## REL AND REM REPAIR KITS

### Extra part in Treater Valve Repair Kits

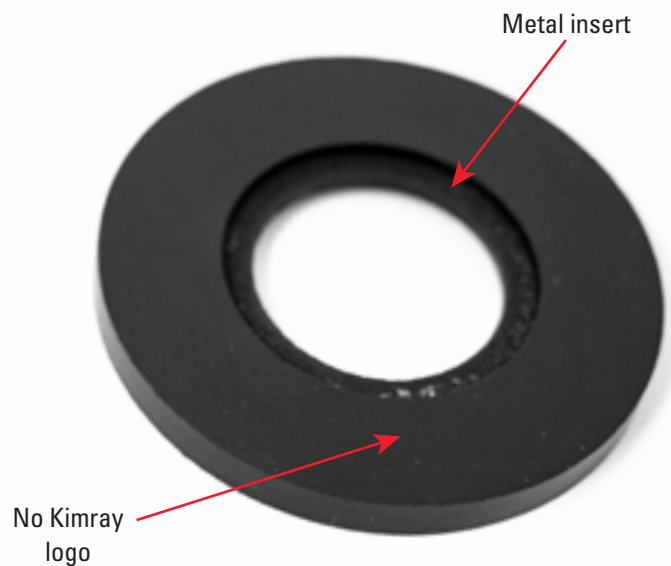
This product notice is to inform you that **REL and REM outgoing repair kits for Kimray Treater Valves** contain an extra part. We made a change to the reversible seat material in May 2018. The new seat style has a metal insert, making it more durable. Some outgoing repair kits contain both the old and new style of seats.

Old Seat

New Seat

Customers who received these kits should discard the extra seat and use the more rigid seat instead.
